**SSHAC Level 2 Questionnaire in Support of Cuba  
Hazard Sensitivity Calculations**

**NRC RAI Letter No. PTN-RAI-LTR-041**

Proposed Turkey Point Units 6 and 7  
Docket Nos. 52-040 and 52-041  
FPL Response to NRC RAI No. 02.05.01-22 (eRAI 6024)  
L-2013-236 Attachment 18 Page 15 of 15

Figure 1B The Phase 2 Earthquake Catalog and Faults of Central Cuba

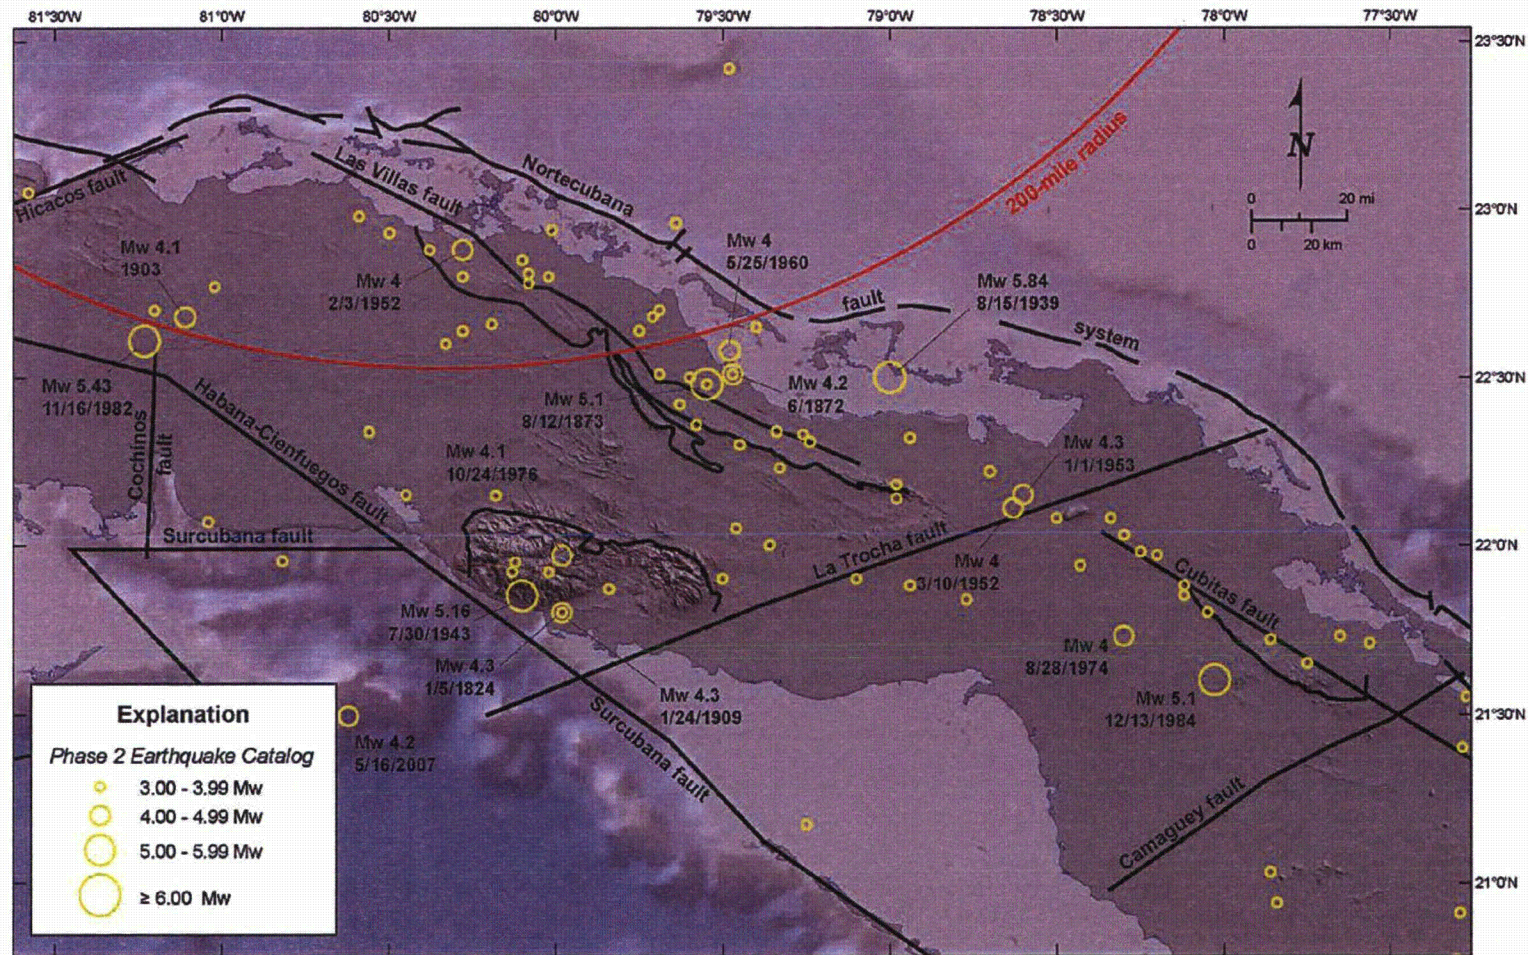
- d) Provide a map of the La Trocha fault trace and nearby seismicity, including location uncertainties and discuss potential sources of the observed seismicity.

The La Trocha fault is mapped as a northeast-striking fault in central Cuba and described as a normal fault “transcurrent to the left” by Cotilla-Rodriguez et al. (2007, p. 517) (FSAR 2.5.1 Reference 494) (Figure 1B). The La Trocha fault is not shown on Pushcharovskiy et al.’s (1988) 1:250,000 scale geologic map of Cuba (FSAR 2.5.1 Reference 846). Review of Pushcharovskiy et al.’s (1988) (FSAR 2.5.1 Reference 846) maps in the vicinity where Cotilla-Rodriguez et al. (2007) (FSAR 2.5.1 Reference 494) map the La Trocha fault indicates no northeast-striking faults cutting Miocene and younger strata. Potentially, this structure is buried by the strata and could be pre-middle Miocene in age.

Figure 1B indicates only sparse seismicity from the Phase 2 earthquake catalog near the La Trocha fault. Only four earthquakes from the Phase 2 catalog are located within 6 miles (10 kilometers) of the fault trace, the largest of which is the January 1, 1953  $M_w$  4.3 earthquake. As described in part a) above, earthquake location errors are not shown on Figure 1B because the data with which to estimate these errors for each earthquake are not available. Cotilla-Rodriguez et al. (2007) (FSAR 2.5.1 Reference 494) suggest a possible association between three earthquakes of less than or equal to MSK intensity V (approximately MMI V) and the La Trocha fault. Some of the seismicity near this structure occurs near its projected intersection with the Cubitas fault (Figure 1B). However, as described in part a), the association of these earthquakes with the La Trocha fault or another mapped or unmapped fault is problematic due to the uncertainties associated with the locations of both faults and earthquakes in Cuba.

**Figure 2 Geologic Maps of Sierra Maestra Region of Cuba  
(Rojas-Agramonte et al. 2005)**

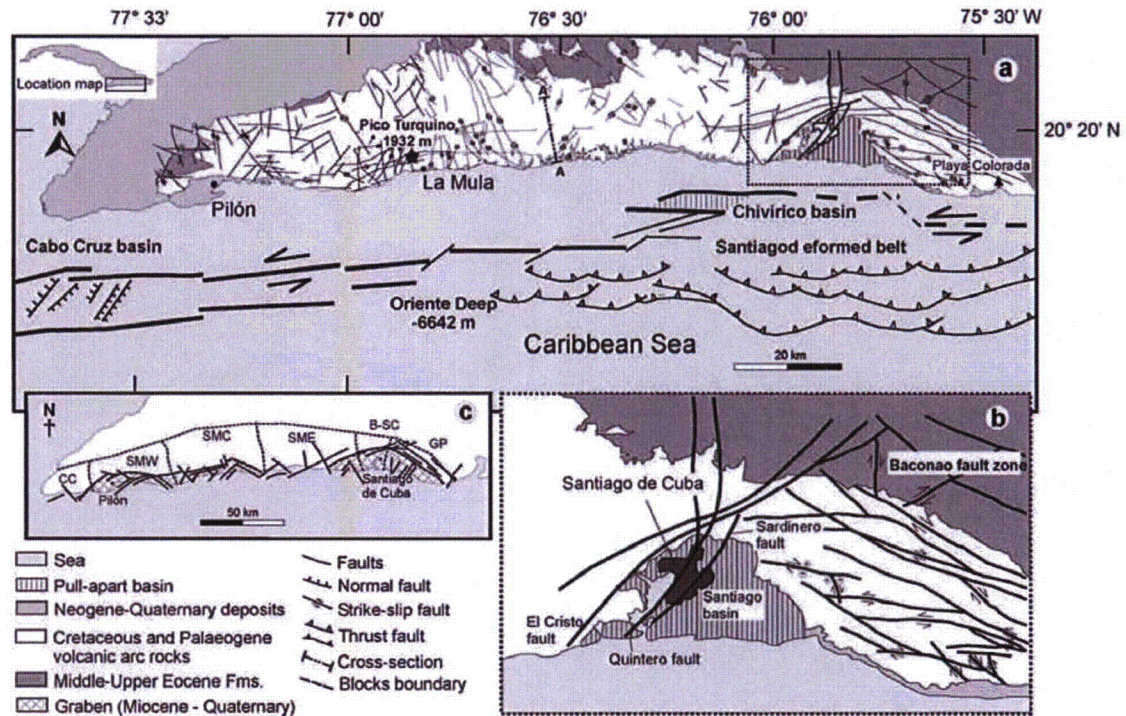
- e) Provide map and discussion of the faults associated with the Sierra Maestra. Consider for example Taber (1931) 1 which describes a scarp associated with the Sierra Maestra as "so fresh that its age must be measured in hundreds of years rather than tens of thousands." In addition discuss the relationship of these faults to nearby seismicity.

The Sierra Maestra is an east–west-trending mountain range in southernmost Cuba, located approximately 450 miles (725 kilometers) from the site and adjacent to the offshore Oriente fault. Figure 2 shows a simplified depiction of faults in the Sierra Maestra, based on mapping by Rojas-Agramonte et al. (2005). The Oriente fault and near-shore portion of the Sierra Maestra are an area of abundant ongoing seismicity (Figure 1C) and neotectonic faulting (Oliva Gutierrez 1989, plate IV.3.2-3; Rojas-Agramonte et al. 2005). Taber’s (1931, p. 532) observation from the near-shore Sierra Maestra at Puerto Pelado ridge near Santiago de Cuba of a “scarp so fresh its age must be measured in hundreds of years” is consistent with this active tectonic setting.

The scarps in the Sierra Maestra may be related to some of the seismicity in southeastern Cuba. Given the proximity to the modern plate boundary, as well as the abundant moderate- to strong-magnitude seismicity (Figure 1C), there almost certainly are active faults in this region. However, as described in part a), the confident association of specific earthquakes with a given Sierra Maestra fault is problematic due to the uncertainties associated with the locations of both faults and earthquakes in Cuba. For the purposes of characterizing ground-motion hazard at the site, the entire plate boundary rate is modeled on the offshore Oriente fault source and is not represented as a more complex series of diffuse faults along the plate boundary. A thin strip of the near-shore portion of the Sierra Maestra is excluded from the Cuba areal seismic source zone (revised FSAR Figure 2.5.2-217). The seismic moment release from this thin near-shore portion of the Sierra Maestra is assumed to be related to deformation associated with the Oriente fault system and therefore is included in the seismic source model as part of the Orient fault-East seismic source. The remainder of the Sierra Maestra is included in the seismic source characterization as part of the Cuba areal source, and the seismicity observed from this portion of the Sierra Maestra is included in the assessment of seismicity recurrence rate for the entire areal source.

Figure 1A Fault Map of Western Cuba Showing Earthquakes from the Phase 2 Earthquake Catalog.

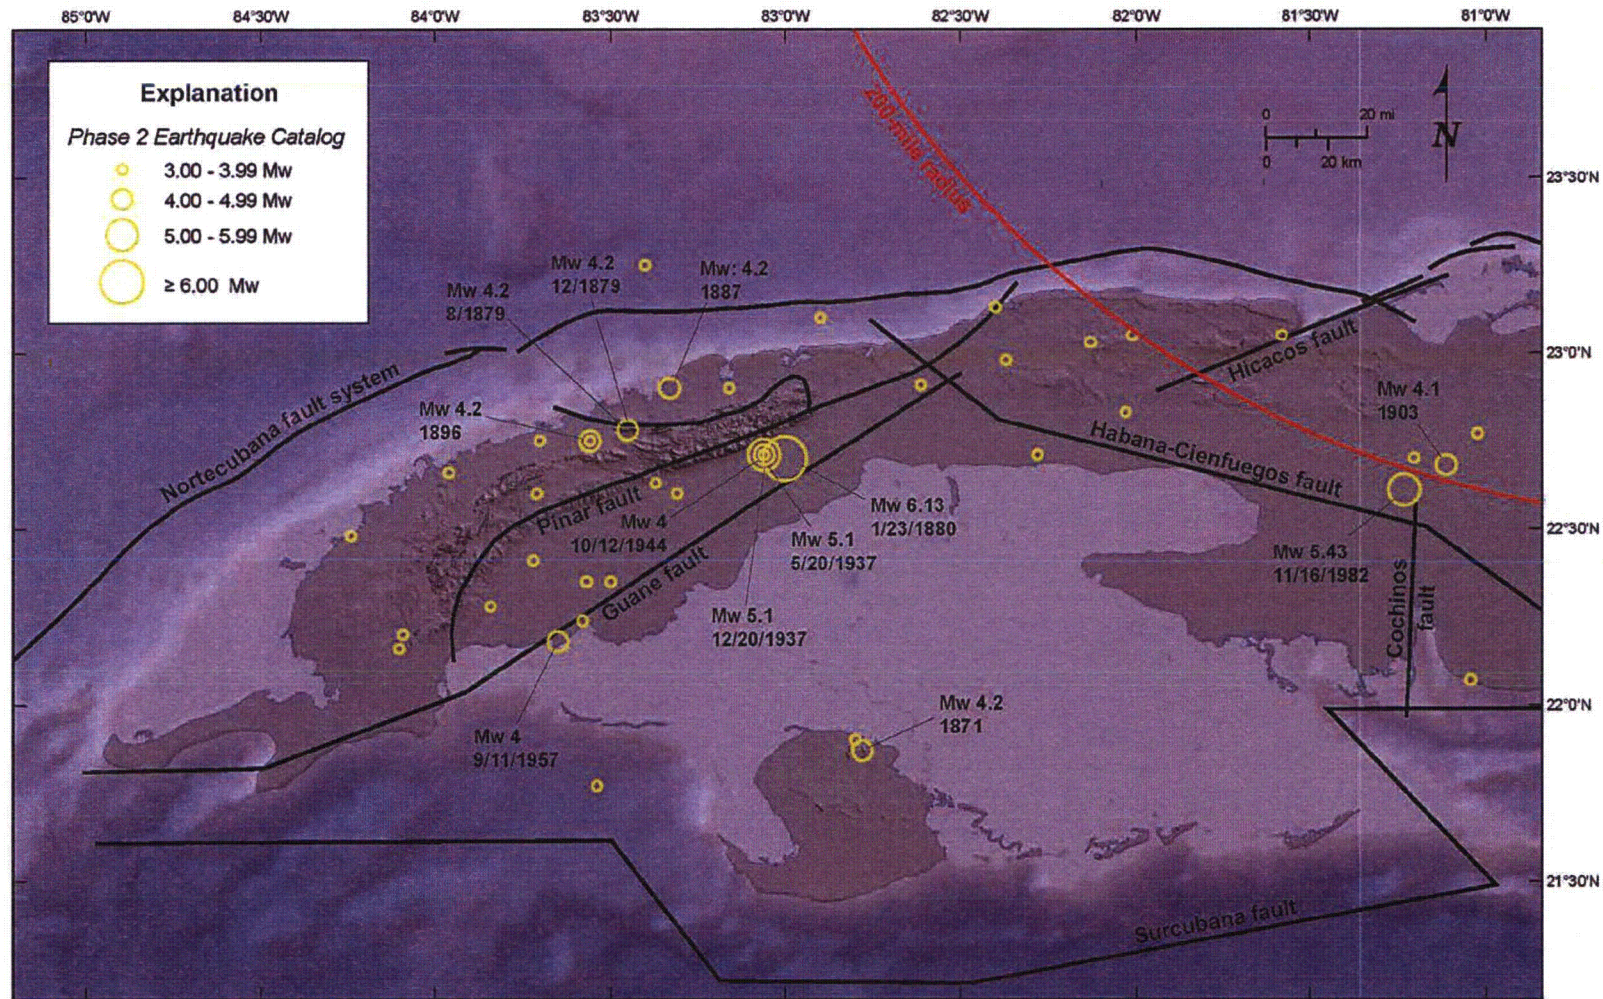
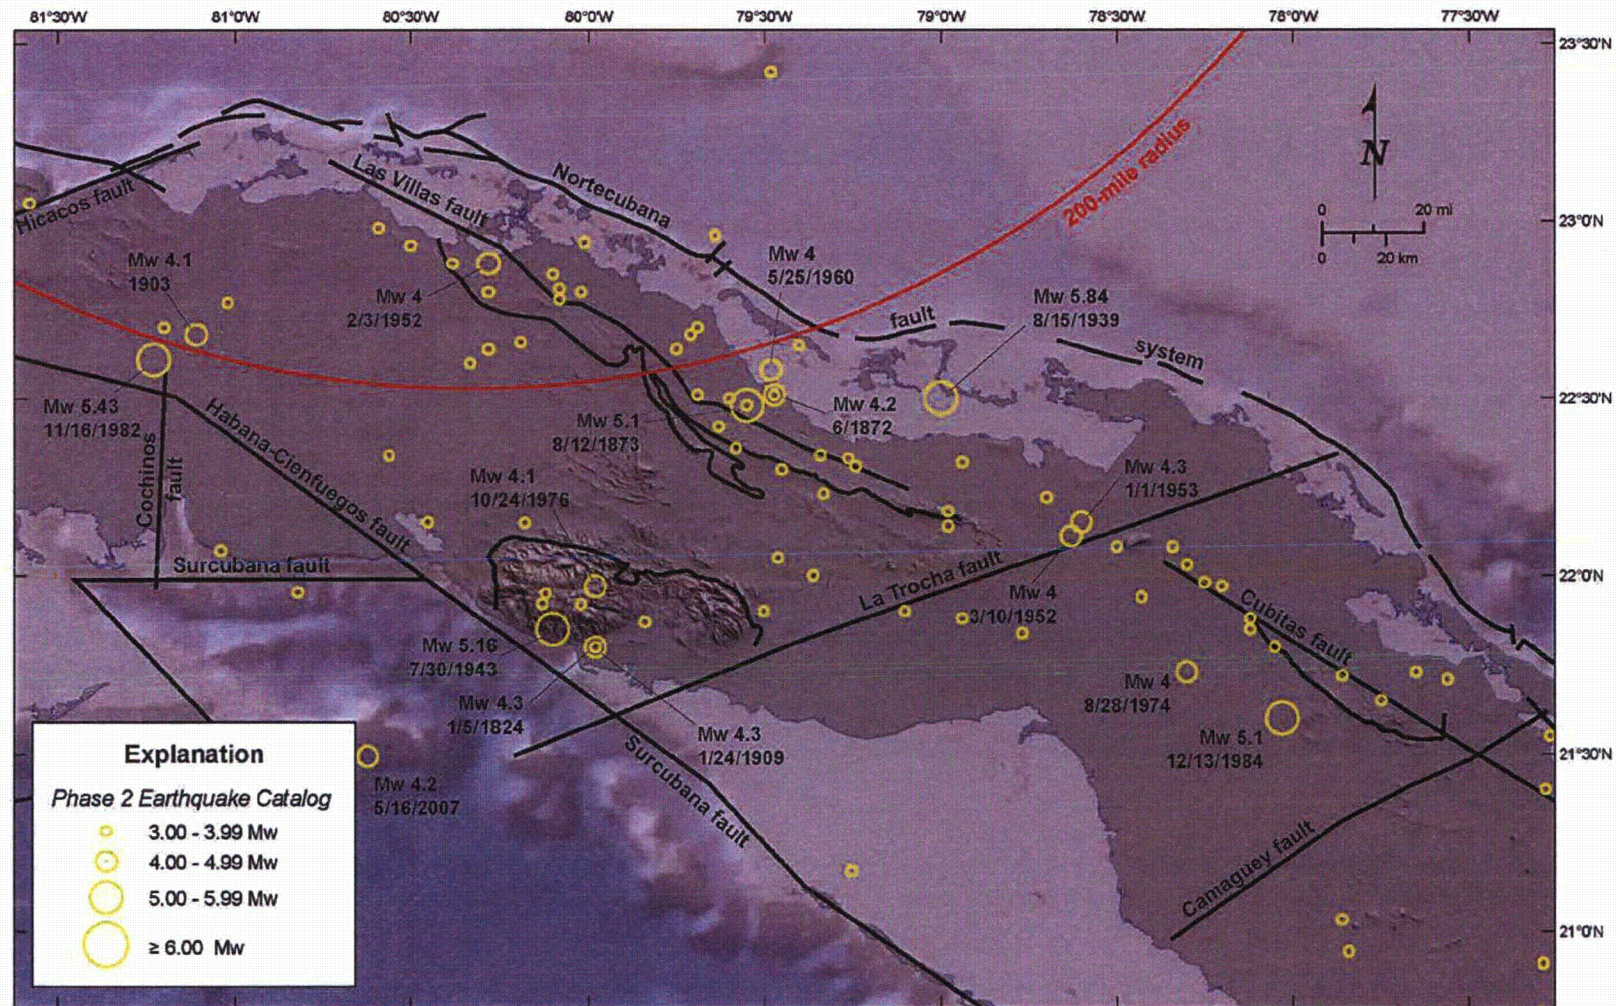
- a) Provide a map of the Cochinos fault with respect to topography and bathymetry, and discuss if the association of the Cochinos fault with bathymetric relief provides geologic evidence for activity.
- b) Map seismicity with respect to the Cochinos fault trace, showing location uncertainties, and discuss the relationship of the fault to seismicity.

Various researchers present different locations and extents for the Cochinos fault. For example, Figures 1A and 1B show the location of the Cochinos fault after Hall et al. (2004) (FSAR Reference 770), who indicate the fault at its nearest point is approximately 205 miles (330 kilometers) from the Turkey Point Units 6 & 7 site. Cotilla-Rodriguez et al. (2007) (FSAR Reference 494) suggest this fault may extend northward to within 175 miles (280 kilometers) of the site, whereas mapping by Mann et al. (1990) (FSAR Reference 493) indicates a closest distance of approximately 210 miles (340 kilometers).

Earthquake location errors are not shown on Figures 1A and 1B because the data with which to estimate these errors for each earthquake are not available. According to Cotilla-Rodríguez et al. (2007) (FSAR 2.5.1 Reference 494, p.518), the "epicenter determination [for earthquakes] in the western, central, and central-eastern [portions of Cuba] have limitations because of scarce or no permanent seismic stations." Regarding the locations of pre-instrumental earthquakes in Cuba, Garcia et al. (2003) (FSAR 2.5.1 Reference 489, p. 2,569) state that, "Taking into account the complexity of the Cuban tectonic environment, the poor knowledge about the kinematic evolution of the principal fault systems, and the uncertainty in the hypocentral location of historical events (uncertainty of 15-20 kilometers or more in the historical coordinates is reasonable), it is impossible to associate earthquakes with individual faults." Therefore, the association of this sparse seismicity with the Cochinos fault or another mapped or unmapped fault in the vicinity is problematic due to the uncertainties associated with the locations of both faults and earthquakes in Cuba.

Figure 2 Geologic Map of Central Cuba Showing the Cochinos Fault (modified after Oliva Gutierrez 1989 plate III.1.2-3)

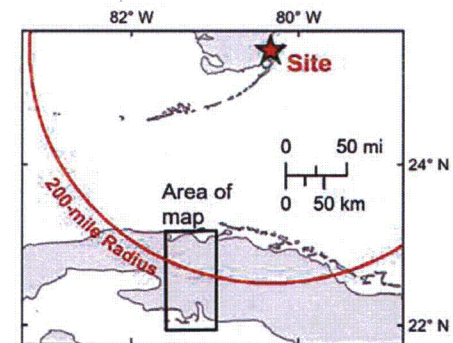
**a) Provide a map of the Cochinos fault with respect to topography and bathymetry, and discuss if the association of the Cochinos fault with bathymetric relief provides geologic evidence for activity.**

unnamed fault in the vicinity of the Cochinos fault that extends from Cuba's northern coast where it is mapped in Pliocene-age deposits southward into the Bahia de Cochinos (Figure 2). The southernmost 18 miles (30 kilometers) of this fault are shown by a dashed line (Figure 2). At its nearest point, this fault is approximately 185 miles (300 kilometers) from the site. The 1:2,000,000 scale neotectonic map of Cuba from this atlas (Oliva Gutierrez 1989 plate III.2.4-8) shows an approximately 87-mile-long (140-kilometer-long) unnamed fault in the vicinity of the Cochinos fault, the southernmost 30 miles (50 kilometers) of which is offshore southern Cuba and shown by a dashed line. To the north, this fault on the neotectonic map is truncated by the Hicacos fault. The Cochinos fault is depicted and labeled on the 1:2,000,000 scale lineament map from this atlas (Oliva Gutierrez 1989 plate III.3.1-11). On this map, the Cochinos lineament is shown as an approximately 90-mile-long (140-km-long) feature, the southern 25 miles (40 km) of which is located off the southern shore of Cuba and labeled as "supuestos" (assumed or postulated). The 1:1,000,000 scale geomorphic map from the *Nuevo Atlas Nacional de Cuba* (Oliva Gutierrez 1989 plate IV.3.2-3) shows an approximately 37-mile-long (60-kilometer-long) unnamed fault in the vicinity of the Cochinos fault. The map explanation indicates that this fault cuts a Quaternary-age marine abrasion platform that is at an elevation of either 2 – 3 meters or 5 – 7 meters above sea level. They do not provide an explanation for the lack of specificity in elevation of the platform nor do they provide a precise age for the Quaternary abrasion platform.

The southern Cochinos fault is grossly expressed in the topography and bathymetry in the Bahia de Cochinos (Figure 2). The Cochinos fault is the only onshore feature in intraplate Cuba identified as "neotectonic" by Mann et al. (1990) (FSAR Reference 493) (FSAR Figure 2.5.1-286). They map the Cochinos fault as two parallel, north-northwest-striking normal faults that form a graben (FSAR Figure 2.5.1-286). The morphology of Bahia de Cochinos is consistent with this interpretation and suggests the possibility of fault control on the landscape. Cotilla-Rodríguez et al. (2007) (FSAR Reference 494) classify the Cochinos fault as active based on the possible association of seismicity with the fault. Cotilla-Rodríguez et al. (2007) (FSAR Reference 494, p. 514) provide no geologic evidence for activity on the Cochinos fault and describe the fault as "covered by young sediments." Indeed, the most detailed geologic maps inspected in the area (1:250,000 scale) show no fault cutting Miocene and younger strata (Pushcharovskiy et al. 1988) (FSAR Reference 846). It is not clear whether the Cochinos fault is depicted on Perez-Othon and Yarmoliuk's (1985) (FSAR Reference 848) inset map of fault ages in Cuba, but they seemingly indicate a Paleogene age for a northern extension of this fault. Pushcharovskiy's (1989) (FSAR Reference 847) 1:500,000 scale tectonic map of Cuba shows and labels the approximately 60-mile-long (100-kilometer-long) Cochinos fault. This fault does not extend as far north as the Hicacos fault, and the southern approximately 50 miles (80 kilometers) are shown as a dashed line. Garcia et al. (2003) (FSAR Reference 489) provide no discussion of the Cochinos fault.

**Figure 2 Escarpments and Postulated Faults in the Southern Straits of Florida  
from Reference 2**

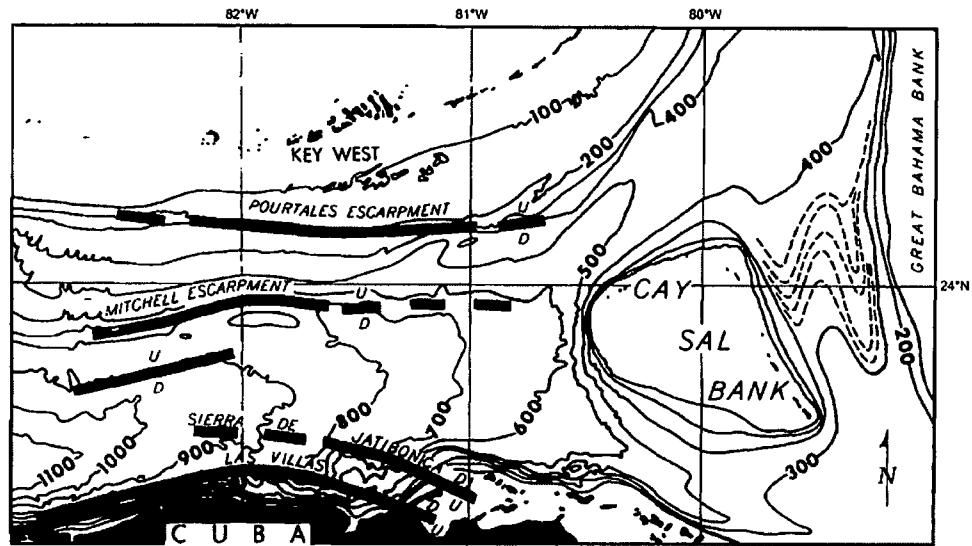
- a) Provide more detail from the Cotilla-Rodríguez et al. (2007) paper regarding the young eroded scarps of the Las Villas fault and specifically address Cotilla's conclusion that the fault is Pliocene-Quaternary in age.
- b) In the context of the chronology of geomorphic surfaces on Cuba, clarify the distinction between erosional processes that may have recently created "young" fault-line scarps along the Las Villas fault and Quaternary tectonic fault scarps.
- c) Discuss bathymetric evidence for the offshore location and recency of faulting along the Las Villas fault.
- d) Address the alignment of epicenters shown on Figure 2.5.1-267 along the Las Villas fault with respect to its tectonic activity. Please plot the uncertainties in event locations and include this information in the discussion.

Reference 2 presents compiled bathymetric and seismic reflection data for the Straits of Florida. They identify escarpments in the Straits of Florida and postulate the existence of faults, including the offshore Las Villas fault (Figure 2). Reference 2 indicates that "since traverses could not be made within 12 [nautical miles] of Cuba, no seismic reflection profiles were obtained of these steep and complex slopes." As such, they base their offshore mapping of the Las Villas fault on Khudoley's previous mapping and on their compiled bathymetric data. The depiction in Reference 2 of the offshore Las Villas fault extends for approximately 120 miles (200 kilometers) from roughly Matanzas Bay westward to Havana. Reference 2 states that "the Las Villas fault appears to be reflected in the bathymetry as a scarp", but they do not provide any description of scarp dimensions, including length, height, and continuity.

**Figure 3 Fault Map of Central Cuba Showing Earthquakes from the Phase 2 Earthquake Catalog**

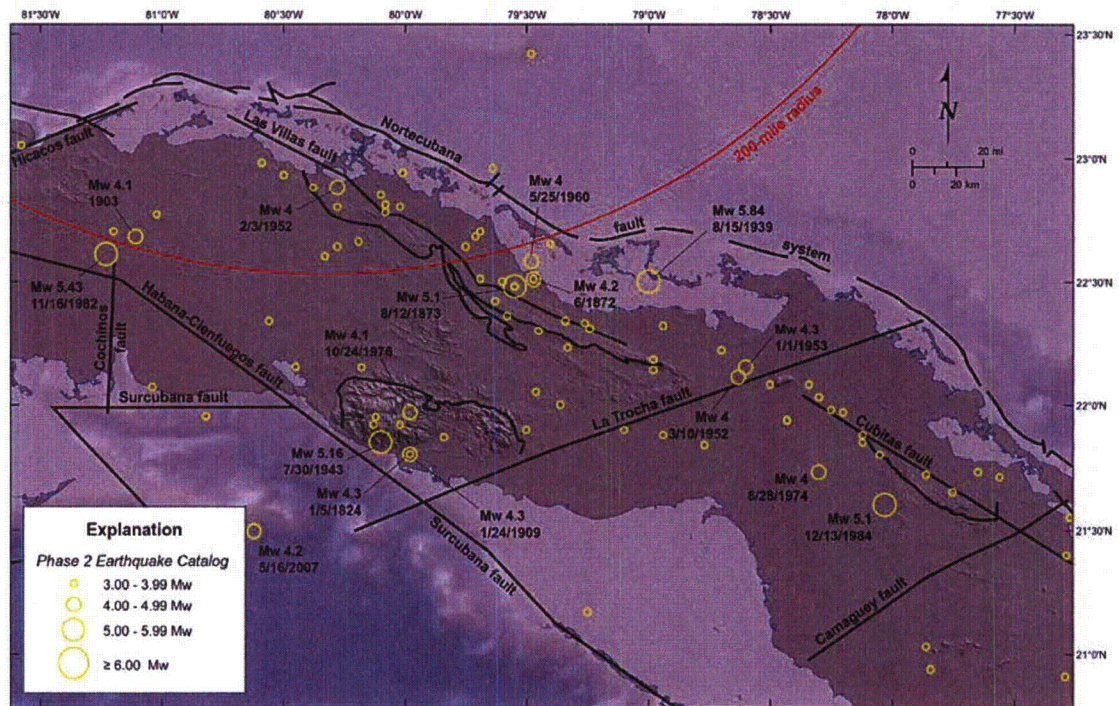
**d) Address the alignment of epicenters shown on Figure 2.5.1-267 along the Las Villas fault with respect to its tectonic activity. Please plot the uncertainties in event locations and include this information in the discussion.**

At a larger scale, Figure 3 shows moderately sparse seismicity from the Phase 2 earthquake catalog (shown on FSAR Figure 2.5.1-267) that may be roughly aligned with Pardo et al.'s (FSAR Subsection 2.5.1, Reference 439) depiction of the Las Villas fault. The Phase 2 catalog is declustered and includes earthquakes of  $M_w$  3 and above. These earthquakes include both instrumentally located earthquakes and pre-instrumental earthquakes whose locations are based on historical felt intensity reports. The accuracy of the instrument-derived earthquake locations is limited by the lack of permanent seismic recording stations in Cuba, especially for lower-magnitude earthquakes. In fact, many of the earthquake magnitudes and locations from the instrumental era are intensity-based as well, and therefore, the uncertainties in locations of Cuban earthquakes are both high and variable. The accuracy of intensity-based locations is a function of the number and reliability of felt reports, the population density and distribution, and other factors. Even for earthquakes with well-constrained intensity centers, there remains ambiguity in the location of the epicenter because of possible seismic wave directivity effects and other seismologic

A total of 33 earthquakes from the Phase 2 earthquake catalog are located within approximately 6 miles (10 kilometers) of the Las Villas fault along its length. Of these, 29 are located northeast of the trace of this southwest-dipping fault, with the remaining four located southwest of the fault trace. The largest earthquake near the Las Villas fault is the August 12, 1873  $M_w$  5.1 earthquake, located approximately 3 miles (5 kilometers) northeast of the fault (Figure 3). Cotilla-Rodriguez et al. (FSAR Subsection 2.5.1, Reference 494) indicate focal mechanisms for these earthquakes are unavailable, so it is not possible to assess whether these possibly roughly aligned epicenters occurred on the Las Villas fault or on another fault or faults.
